U. S. NUCLEAR REGULATORY COMMISSION  
REGION I

Report No. 50-387/83-03  
50-388/83-01  
Docket No. 50-387 (CAT B) 50-388 (CAT A)  
NPF-14  
License No. CPPR-102 Priority -- Category --

Facility Name: Susquehanna Steam Electric Station

Inspection Conducted: January 12 - March 8, 1983

**STANDBY GAS TREATMENT SYSTEM SIMPLIFIED SCHEMATIC**

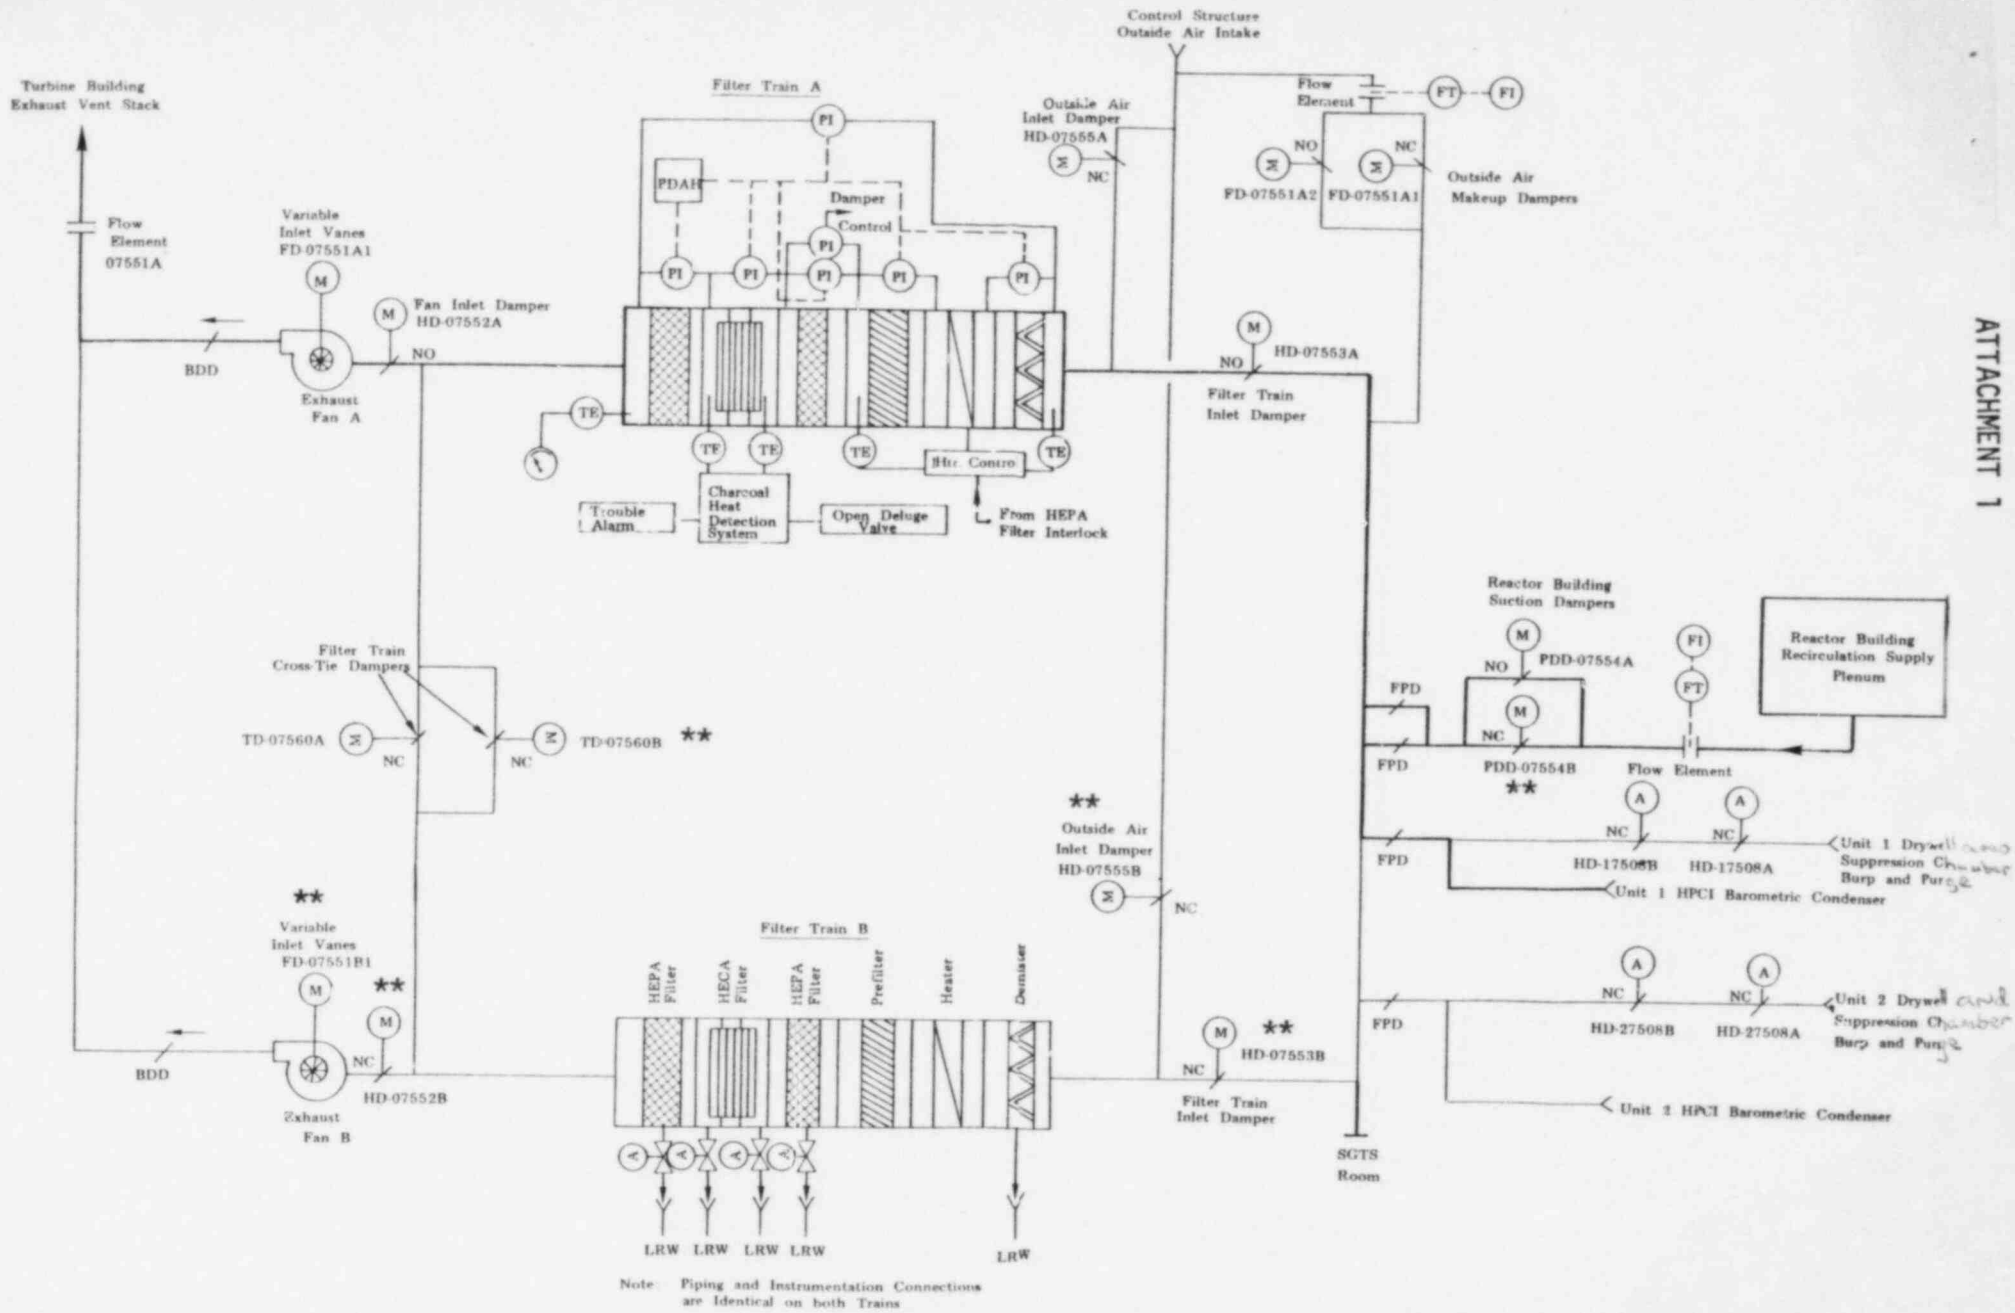
- a. On February 28 at 11:20 a.m. the licensee removed SGTS subsystem A from service to remove test cannisters from the charcoal filter beds. To provide personnel protection the licensee determined that cross-tie dampers (between the A and B subsystems) TD 07560A and TD 07560B were required to be blocked shut. The operator accomplished this by opening circuit breaker 11 on panel 1Y236 and breaker 11 on panel 1Y246. By opening these breakers the licensee not only disabled the power supply to the cross-tie dampers, but also disabled both trains of the Standby Gas Treatment System. The breakers supply control power to the SGTS fans A and B discharge vanes (FD-07551A and B). With the breakers open the discharge vanes will not open on the initiation of the SGTS, thus rendering both trains inoperable. By 11:15 a.m. on March 1 the test cannisters had been removed from the filter bed and all permit tags were removed. The breakers on panels 1Y236 and 1Y246 were not shut since the operators intended to subsequently install a permit on train "B" of the SGTS to remove test cannisters.

- b. Numerous indications in the control room and several alarms were received which should have indicated to the operators that the breakers opened on 1Y236 and 1Y246 supplied more than just the crosstie dampers. The following damper indications were lost on Control Room Panel OC 681:

- FD-07551A2 and B2 - SGTS A and B train outside air makeup dampers.
- HD-07555A and B - SGTS A and B outside cooling air dampers.
- HD-07552A and B - SGTS A and B filter exhaust dampers.
- HD-07553A and B - SGTS A and B filter inlet dampers.
- PD-07554A and B - Reactor Building Recirculation Dampers to SGTS.

Contrary to Administrative Procedure AD-QA-306, Section 6.4 and Attachment B, the review performed by the Unit Supervisor was inadequate since it did not prevent the removal of both subsystems of the SGTS.

Two factors contributed to the operator's inadequate review of the blocking. First, the design drawings were not intended to facilitate blocking reviews by an operator, and the review process was very complex (generation of a controlled set of electrical load lists is in process but not completed); second, the series of drawings needed for an adequate review were not all available in the Control Room. The inspectors needed the following drawings to determine what loads would be lost when the breakers were opened:
